REF: 01023/GA/DJ/L0007

S62A/2023/0021 Moors Field, Station Road, Little Dunmow, Essex

Approval of reserved matters for appearance, landscaping, layout and scale for 160 dwellings and a countryside park pursuant to conditions 1 and 2 of outline planning permission UTT/21/3596/OP

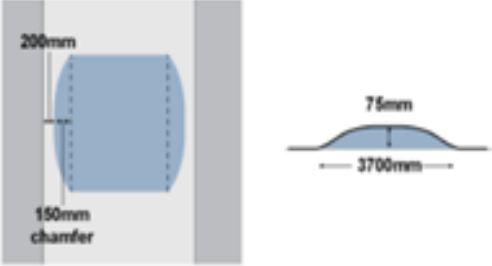
<p>Pedestrian and cycle shared use paths should have a minimum width of 3m in accordance with LTN 1/20 table 6-3.</p>	<p>The routes proposed are 3.5 metres wide.</p>
<p>Dropped kerbs should be provided where they link to the road network in the residential area and details of the accesses to the Flitch Way should be provided.</p>	<p>We consider that this level of additional detail could be conditioned.</p>
<p>The current proposal is to the surface the paths with self-binding gravel. LTN 1/20 (Section 15.2.1) states that surface quality affects the comfort and effort required when cycling. Loose surfaces such as gravel or mud can also present a skidding hazard, increase the risk of punctures and make cycles and clothing dirty in bad weather.</p>	<p>The proposed routes through the countryside park are proposed to be surfaced with self-binding gravel (i.e. hoggin). We consider that this approach balances the need for a wearable surface that is accessible all-year round with the aesthetic and environmental concerns regarding the impact of creating c.2km of asphalt paths through the proposed countryside park. Our client has discussed this approach with Little Dunmow Parish Council and this is their preferred surface type.</p>

<p>Cyclists are also affected by ruts and potholes that can throw them off balance.</p> <p>Smooth, sealed solid surfaces offer the best conditions for everyday cycling. Loose surfaces are also not suitable for wheelchair users. Therefore, the paths should be surfaced with bound material to provide a smooth surface.</p>	<p>LTN 1/20 Section 15.2.5 states that "<i>Outside built-up areas, treatments such as crushed stone may be applied to off-highway routes for aesthetic, heritage or nature conservation</i>". We therefore consider that the proposed surfacing is appropriate.</p> <p>However, should the Inspector consider that some of the proposed routes would benefit from a sealed surface, our client would be willing to accept a condition requiring further details of surfacing to be submitted. In this case, we consider that spray and chip surfacing would be more appropriate than rolled asphalt in accordance with LTN 1/20 Section 15.2.14: "<i>Spray and chip surfacing offers a sealed surface with a more natural appearance than black bituminous surfacing</i>".</p>

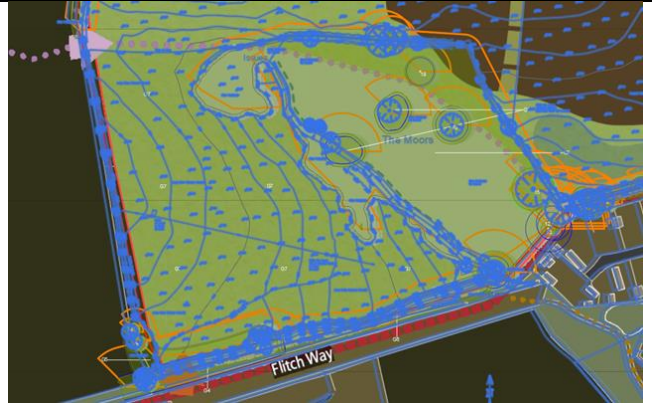
<ul style="list-style-type: none"> • The Design Code stipulates that all dormer windows facing the street frontage must contained gable roofs. The dormer windows proposed on the 2.5 storey building have flat roof types and should be revised to accord with the Design Code. • Nine bungalows are proved as part of the development. The location of the bungalows has not been easily identified on the 'Building Heights Plan contained within the supporting Design and Access Statement. The bungalows should form an integral part to the street scene and ensure that appropriate space is provided around them to ensure that they are not heavy dominated by adjoining built form. • Ensure that all the new homes within the development comply with the Nationally Described Space Standard (NDSS). • Ensure that all new homes within the development conform to the requirements of the approved Design Code by ensuring that all new homes are adopted to provide appropriate mitigation to climate change as outline within the Design and Access Statement submitted in support of the proposals. • The layout of the built form of the dwellings should provide a greater buffer zone or separation distance from Moores Wood to avoid any loss of important trees/vegetation. It is also suggested that appropriate tree protection measures are put in place to ensure that the woodland and the root protection zones are not damaged during construction works. 	<p>In keeping with the site's edge of settlement location, the proposal has been design with green vistas terminating views and that corner turners are provided. All corner plots have side windows and 4 additional house-type variations are now proposed for feature buildings with brick plinths and fully boarded/clad elevations. Two of these new variations (for the Frogmore and Gosford house types) have bay windows to add variety and interest at corner plots.</p> <p>These have been amended.</p> <p>A separate storey heights plan is now submitted to show the location of the bungalows more clearly. They are provided at key locations fronting Station Road, near to the existing woodland and in a location that is in close proximity to existing dwellings at Ainsworth Drive.</p> <p>We can confirm that they do. Floor space figures are shown in the schedule of the Technical Layout.</p> <p>Sustainability and energy efficiency measures are already secured by Condition 37 which requires compliance with the Sustainability and Energy Statement (November 2021) prepared by Turley for the outline application.</p> <p>This issue would appear to have been raised because the submitted plans give the impression that our client's proposals have moved closer to the wood than shown on the outline application plans. This is not the case. The image below shows the tree survey overlaid on the Framework Plan which shows that the woodland extends right up to and in fact over the proposed built form.</p>
